Product Change Notification: MAAN-25FDCG434

CCB 7231.011 Final Notice: Qualification of MMT as a new final test site for AT27C020-90PU, AT27C040-70PU, AT27C040-90PU, AT27C080-90PU, AT27C010-70PU and AT27C020-55PU catalog part numbers (CPN) available in 32L PDIP (.600in) package.

PCN #: MAAN-25FDCG434

CCB 7231.011
Pre and Post Change Summary
PCN #: MAAN-25FDCG434

Pre and Post Change Summary - TUBE

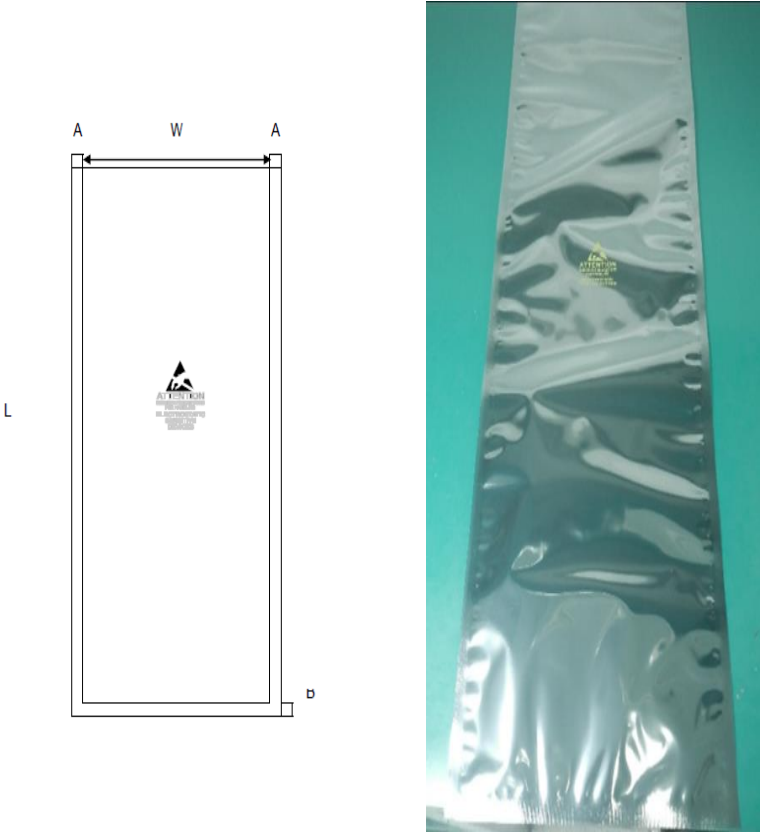
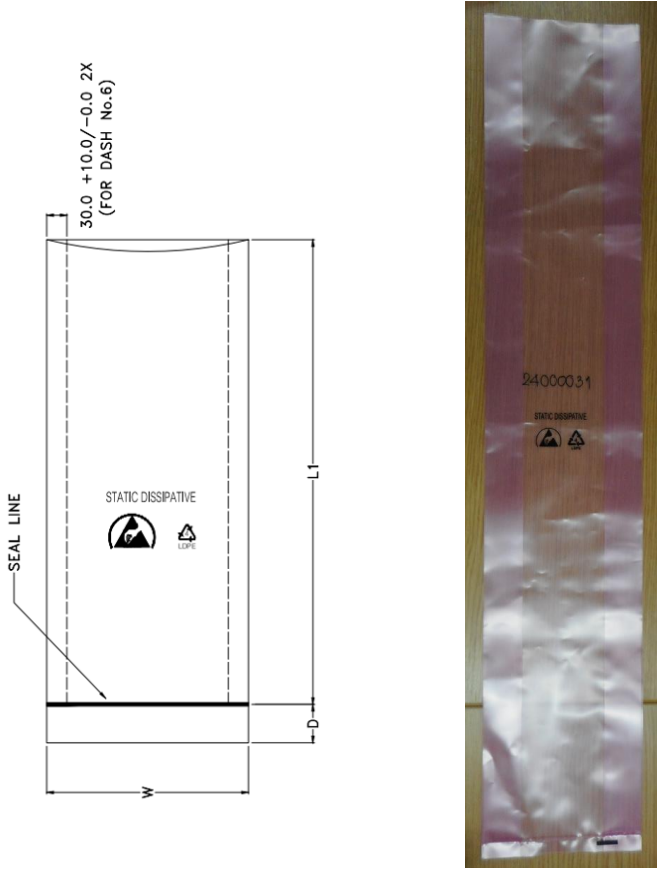
Location	Tube Length (inch)	Dimension	Tube Length between Hole Usage	Unit per Tube	Tube per Bag	Tube Color
MPHL	23.75 +/- 0.05	See on drawing	20.76 +/- 0.03	12	24	Transparent Clear
MMT	23.75 +/- 0.05	See on drawing	20.76 +/- 0.03	12	24	Transparent Clear
